Item Name: Strut

ENGINEERING CHANGE NOTICE NO.

DWG NO. 646.3500

DWG TITLE: STRUT

SHEET 1, ZONE A1 IS:

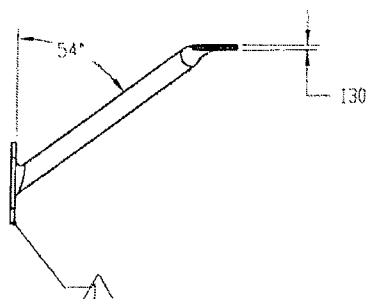
REASON: REVISED DELTA NOTE 1 & 2.

- 1 MATERIAL: AISI 304/ 316 SS SHEET .062 THK
(REF DART SPEC. M304S16GA)
- 2 MATERIAL: AISI 304/316 SS 0.500 OD X 0.049 WALL
(REF DART SPEC. M304TR0.500W0.049)
ENSURE SEAMLESS TUBE IS USED
- 3 FINISH: HARD ANODIZE IAW MIL-A-8625 TYPE III, CLASS 2
COLOR BLACK;
CARDINAL 4860-50 PRETREATMENT PRIMER
PRIME IAW MIL-P-23377J TYPE I CLASS N
4. DEBURR AND BREAK ALL SHARP EDGES
5. WELDS IAW MIL-STD-2219.
TIG WELD WITH FILLER ROD

SHEET 2 IS:

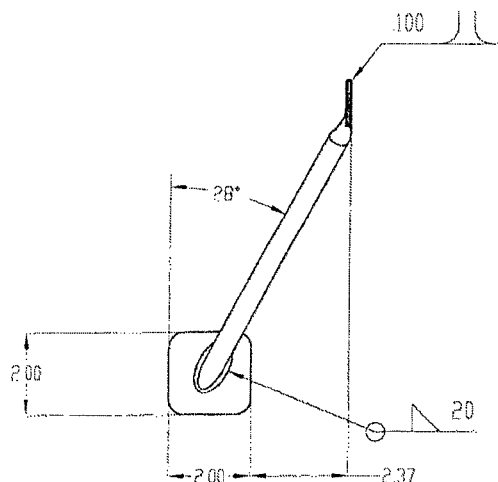
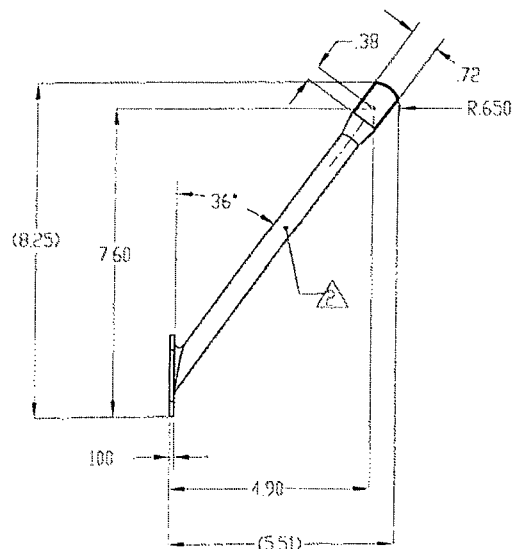
ENGINEERING CHANGE NOTIC. NO. 02440		SHEET 1 OF 1	
DWG NO. 646.3500	REV: NC	PREPARED BY S. HUFF	DATE 06/08/09
DWG TITLE: STRUT		EFFECT ON DWG ☐ INC. ☒ UNINC.	
APPROVED BY: ENGR <i>[Signature]</i>	MFG <i>[Signature]</i>	QC <i>[Signature]</i>	EFFECT: CURRENT ORDER AND STOCK
REASON: REVISED GEOMETRY TO ACCOMMODATE NEW EXISTING AIRCRAFT PROVISIONS			
TRANSACTION CODES (TC): A-ADD C-CREATE R-REVISE D-DELETE

SHEET 2, IS:

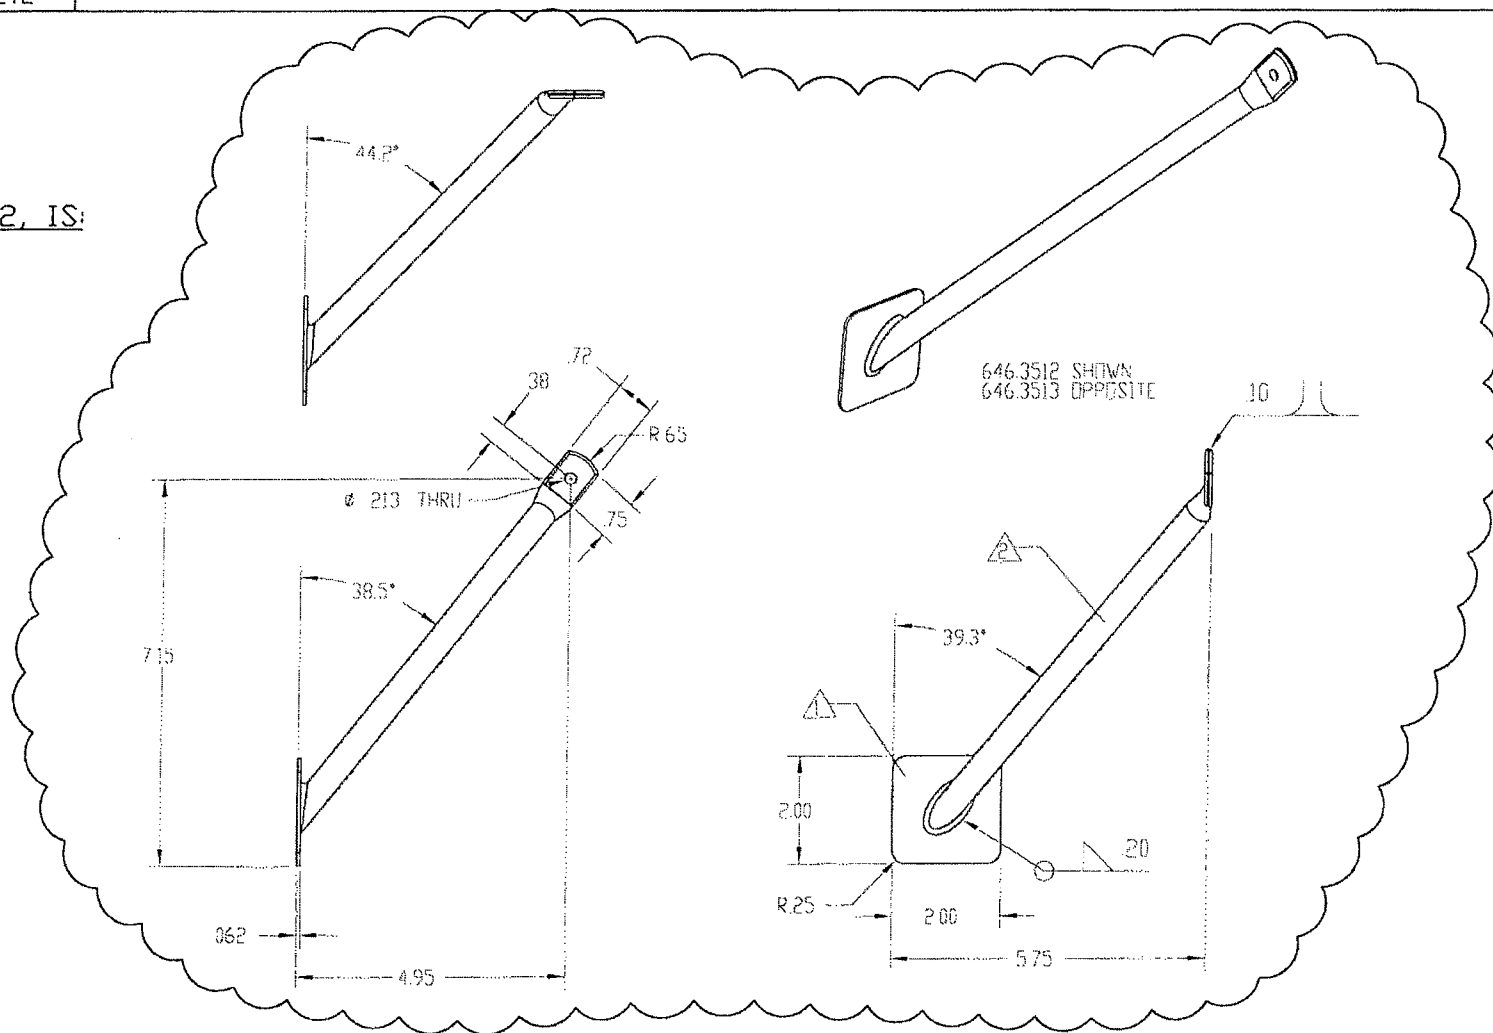
REASON: REVISED ANGLE OF 646.3512 & 646.3513 FOR BETTER FITMENT
